RESPONSE TO REQUEST FOR ADDITIONAL INFORMATION

APR1400 Design Certification

Docket No. 52-046

RAI No.: 491-8613
SRP Section: 09.05.02 – Communication Systems
Application Section:
Date of RAI Issue: 05/26/2016

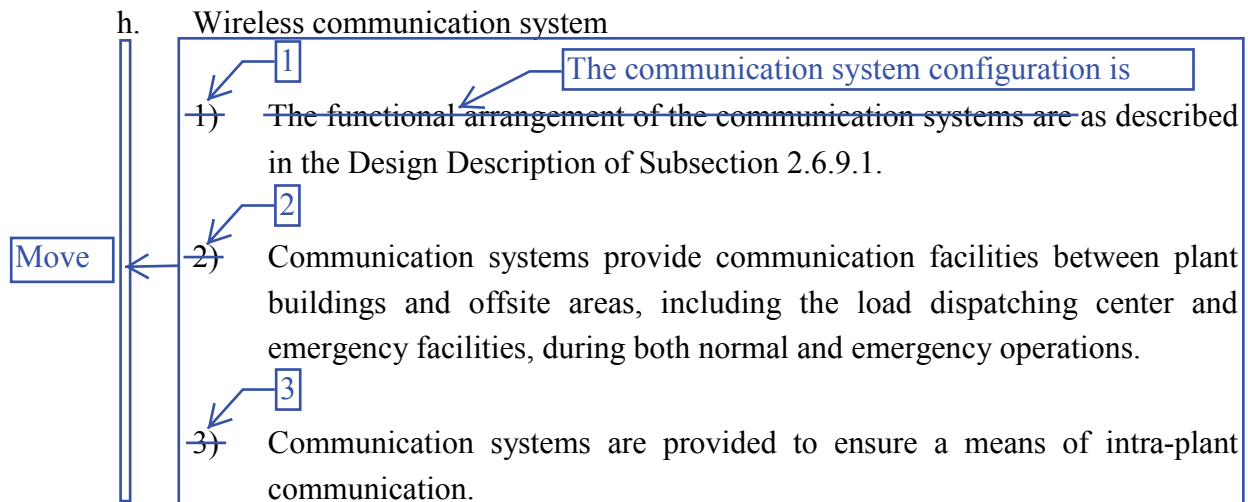
- (a) The applicant needs to clarify what they mean by functional arrangement of communication systems. A definition for functional arrangement of communication systems in APR1400 FSAR Tier 1, Section 2.6.9 is needed. Update FSAR documents accordingly.

- (a) There is editorial error in DCD Tier 1, Subsection 2.6.9.1. Design description 1), 2), and 3) are not sub-descriptions of DCD Tier 1, Subsection 2.6.9.1.h, "Wireless communication system". In this subsection 2.6.9.1, the configuration of communication system is described. Thus "the functional arrangement" will be changed with "the communication system configuration". DCD Tier 1, Subsection 2.6.9.1 will be revised.
